**TOWN OF BROOKLYN  
PLANNING AND ZONING COMMISSION  
Preliminary Regular Meeting Agenda  
Wednesday, July 1, 2020  
6:30 p.m.**

## **ENGINEERING PLAN REVIEW**

The comments contained herein pertain to my review of plans, consisting of six sheets, entitled "6-Lot Subdivision, Prepared for Jeffrey Weaver, Day Street, Brooklyn, Connecticut" prepared by Archer Surveying, LLC and Provost & Rovero, Inc., dated February 7, 2020.

## Site Development Plan "6 Lot Subdivision"

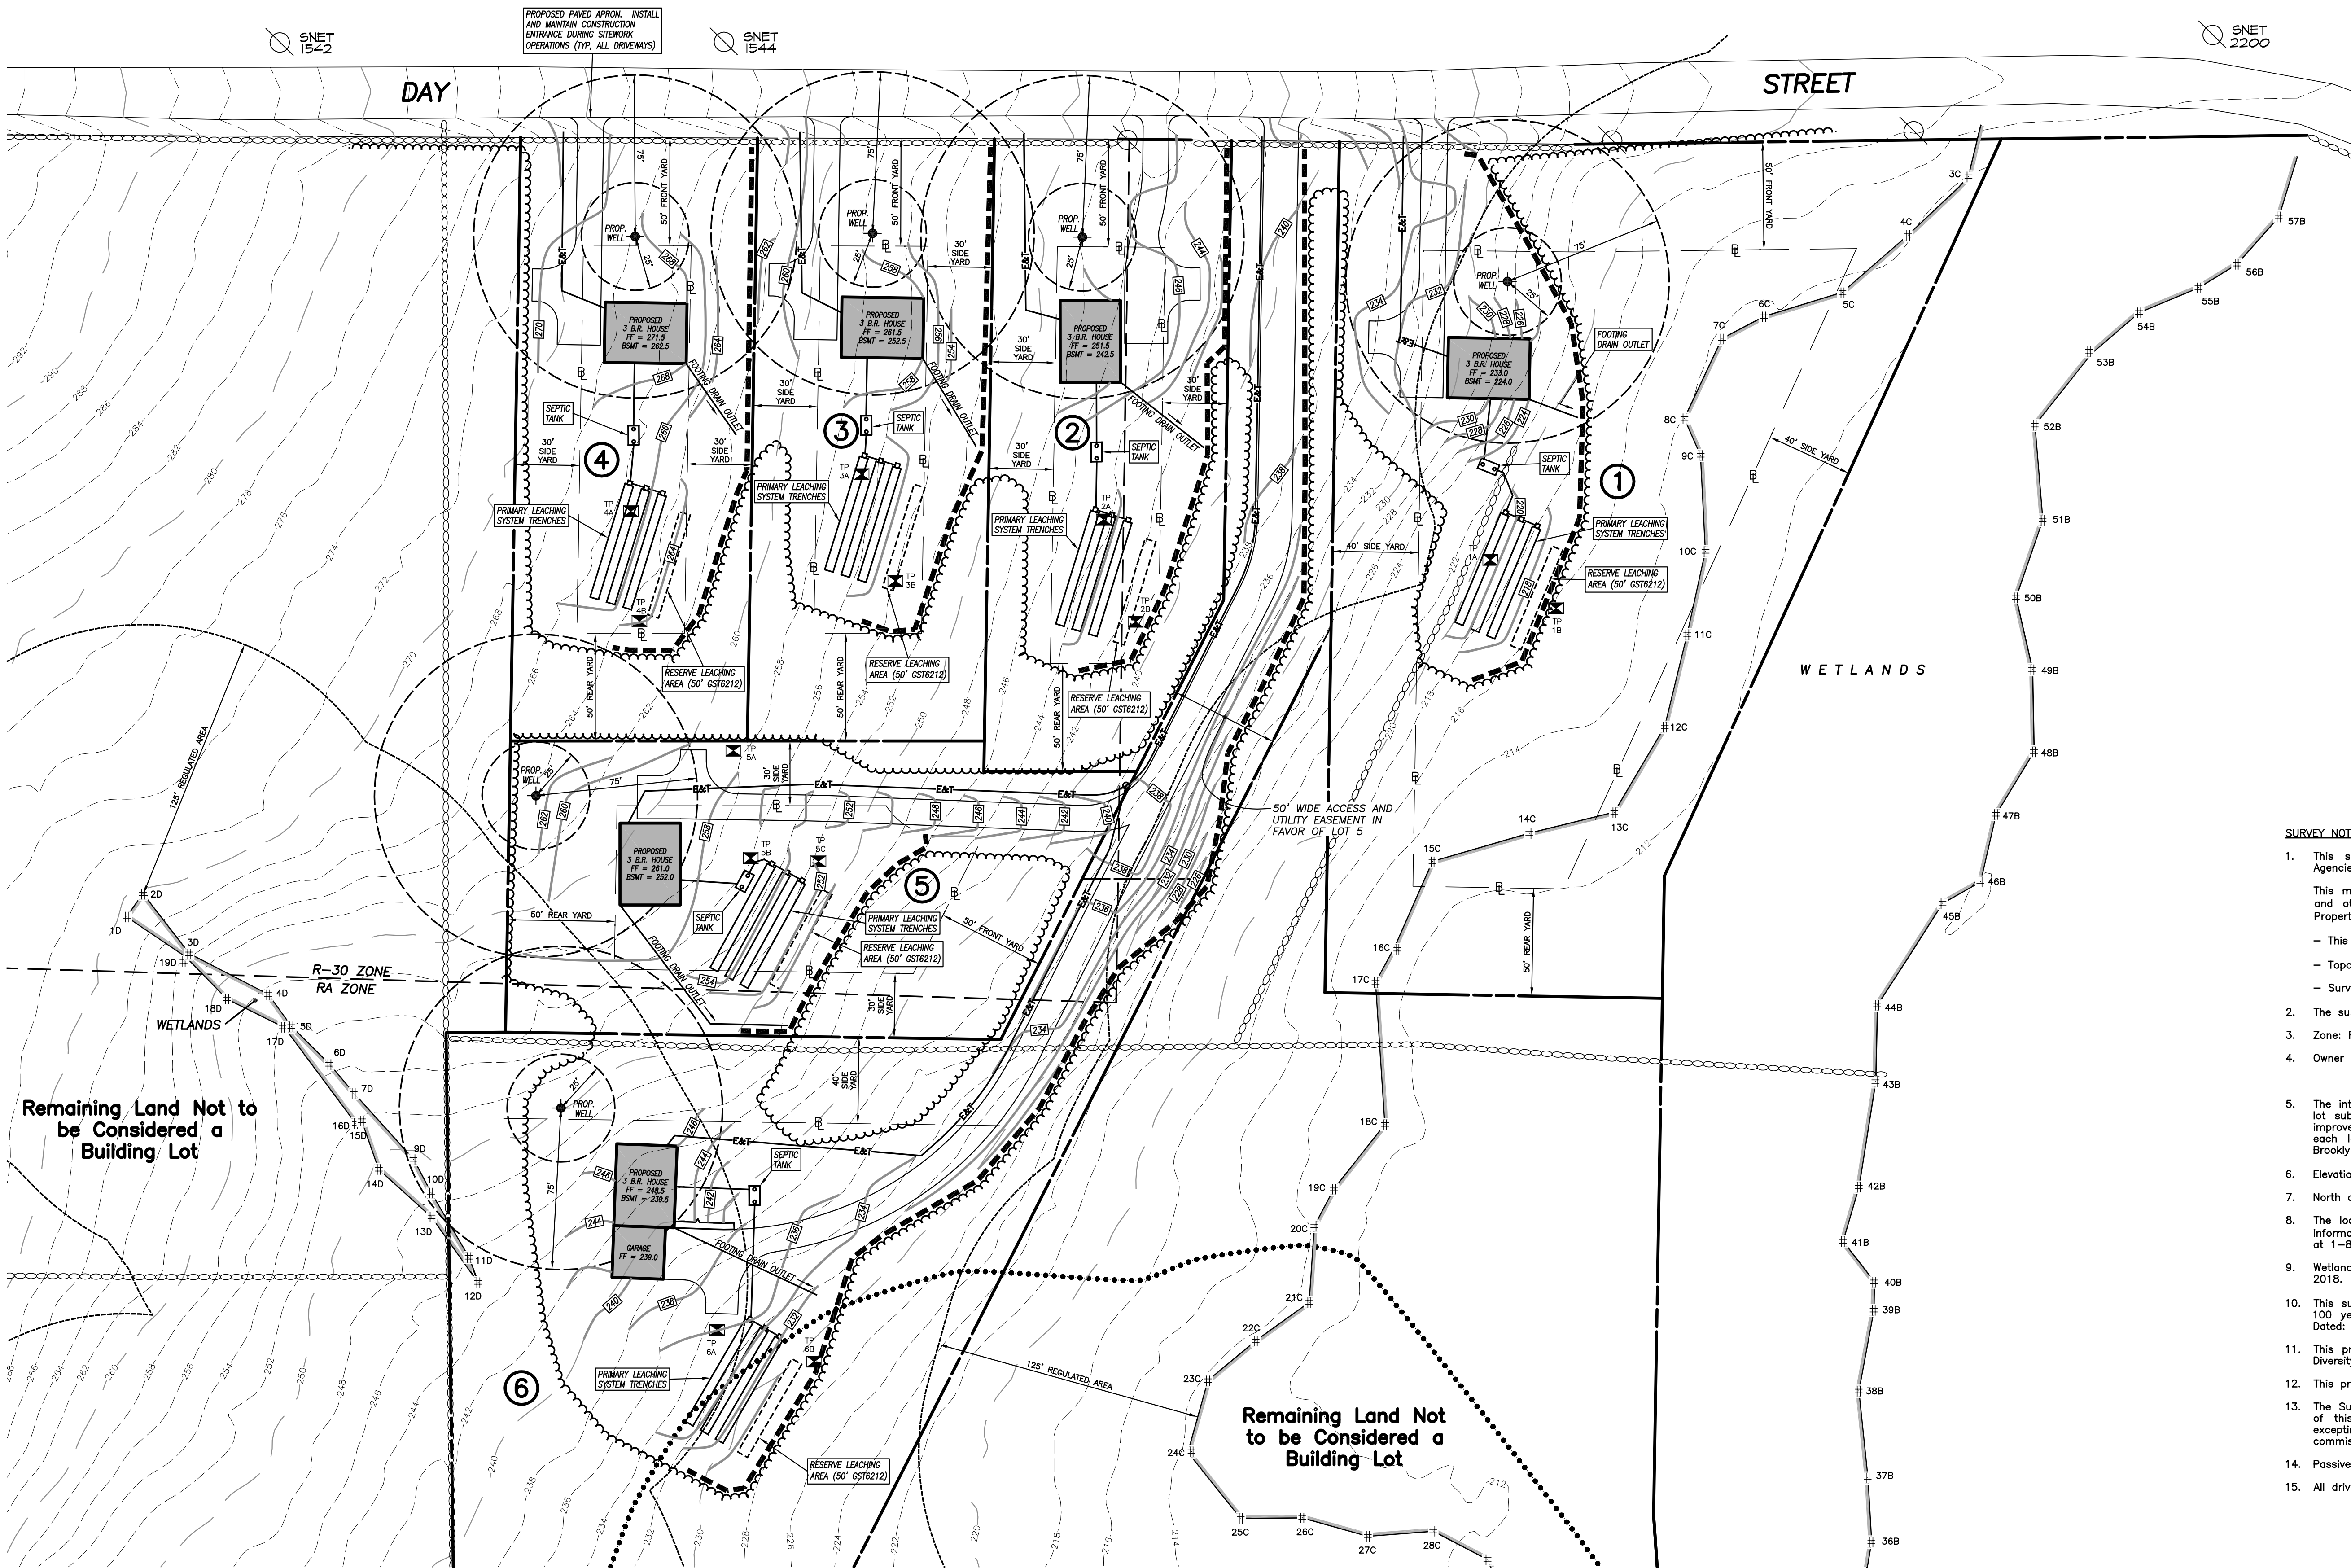
2. The vast majority of the Lot 1 is in the regulated wetland upland review area as well as about half of Lot 6. This may be of concern and should be taken under consideration with respect to future improvements to the building lots after a house is constructed, e.g. additional pavement or impaired impervious areas that could contribute detrimental runoff toward the wetland without any regulatory oversight by the Inland Wetlands and Watercourses Commission or the Planning and Zoning Commission.

Detail Sheet No. 1  
"6 Lot Subdivision"

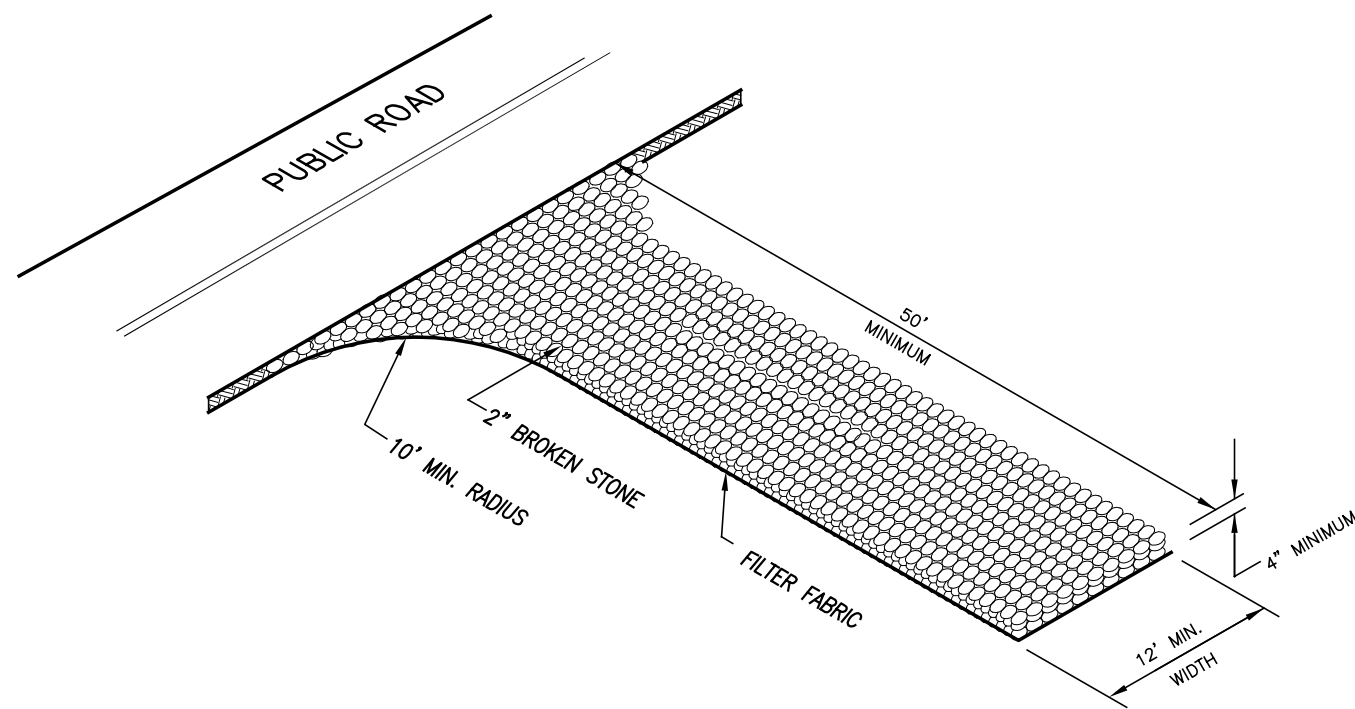
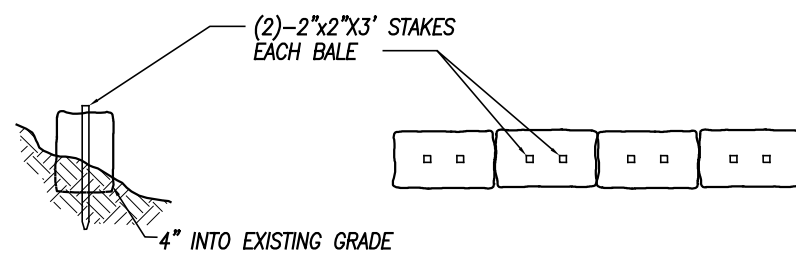
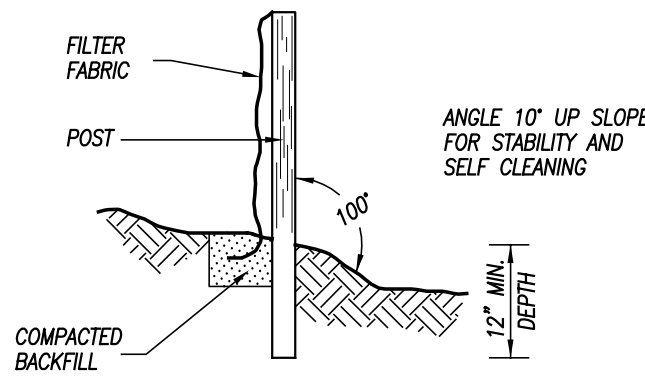
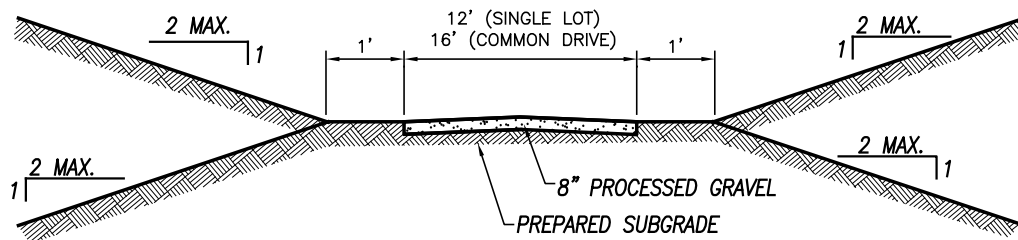
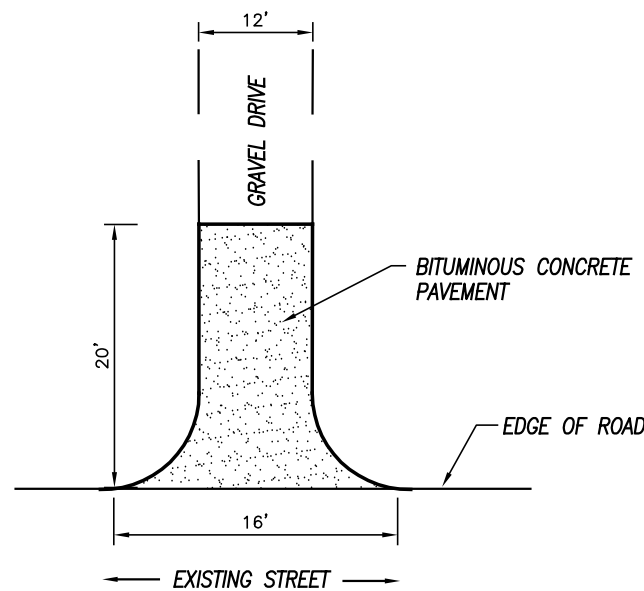
1. Proposed grading along the east side of the proposed driveway in the vicinity of Lot No. 5 is drawn at a 2:1 slope. I recommend that the slope be no less than 3:1 to better establish vegetative growth and reduce the chance of soil erosion, with a note to this effect be included under the heading "Development Control Plan."
2. Note 1 under "Development Control Plan" states that development of the site will be the responsibility of a lot owner. This being the case, I believe it is important that a permanent grass seed mix be spelled out under the heading "Permanent Vegetative Cover" to be sure that all of the development receives a uniform seed treatment.
